Access Compliance Report

Public Rights-of-Way

Intersection ID: 10022679	Main Street: CARNEGIE_BV	Cross Street: N/A	Location:	N
ADA ID: E0AD594CF2B0	Ramp Type: Perp	Initial Pass/Fail: Pass	Overall Compliance: No	Severity Score: 15

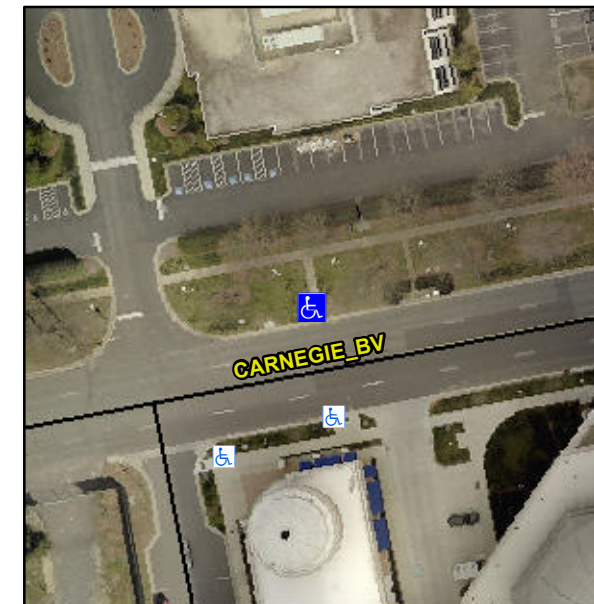
**Not Found, R304.2.2-Perp, R304.3.2-
Para, R305, R304.5.4**

**Remove & Replace Entire Ramp.
Remove & Replace Gutter.**
